DEVELOPMENT REVIEW COMMITTEE (DRC) COMMENT REPORT

PROJECT NAME: Seven on Seventh

CASE NUMBER: R18078

REQUEST: Site Plan Level II Review: 72 Multifamily Residential Units with Additional Height to 90 Feet Utilizing NWRAC Affordable Housing Performance Standards in Northwest

Existing Stormwater Asset Map possibly affected by the Proposed Development

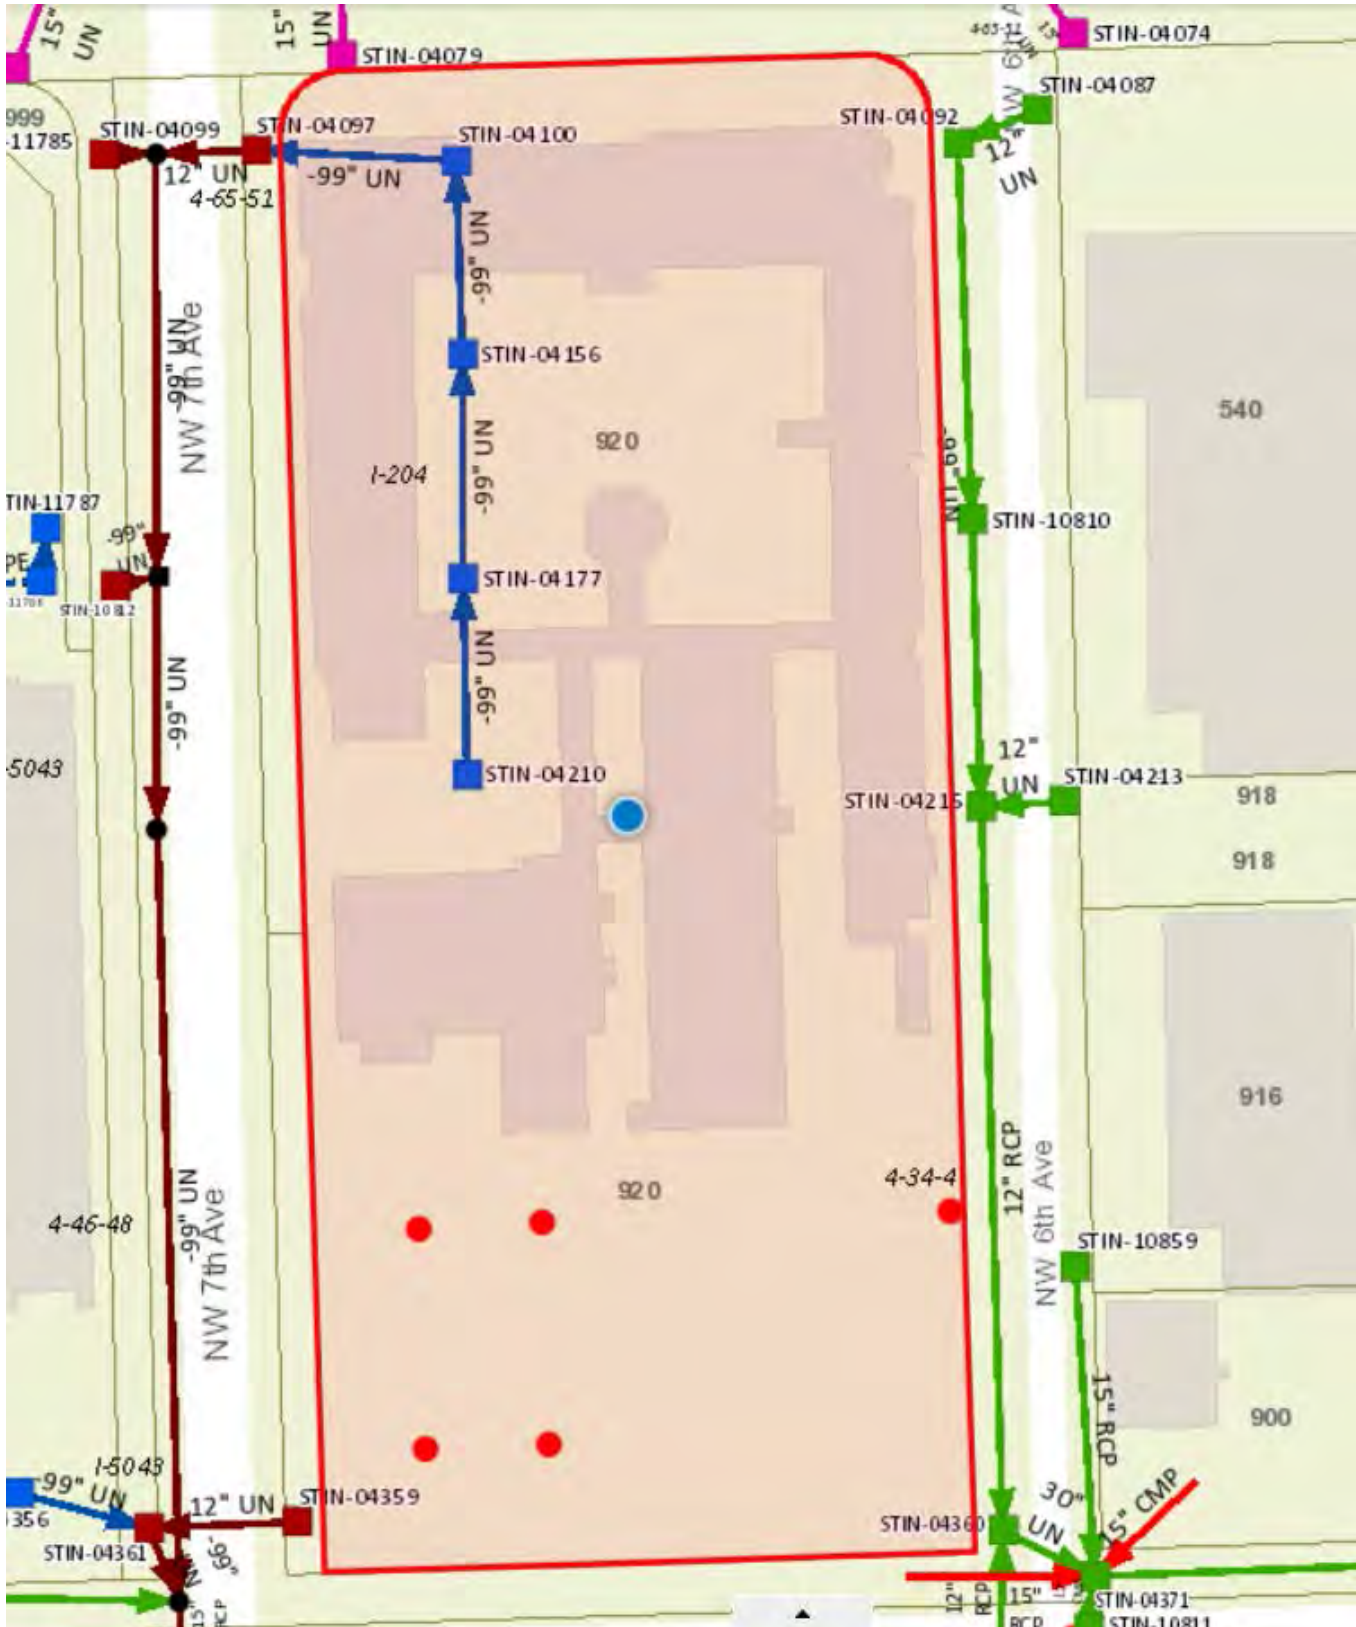
The City owns and maintains stormwater infrastructure adjacent to the proposed development as shown with green line work in the map provided at the end of this report. **Civil plans shall be revised to show the City's stormwater inlet ID #s as identified in the map provided at the end of this report.** The following comments pertain to possible impacts of the proposed development and/or construction activities to the existing condition of the City's stormwater assets. The applicant shall provide an itemized response letter addressing the following comments:
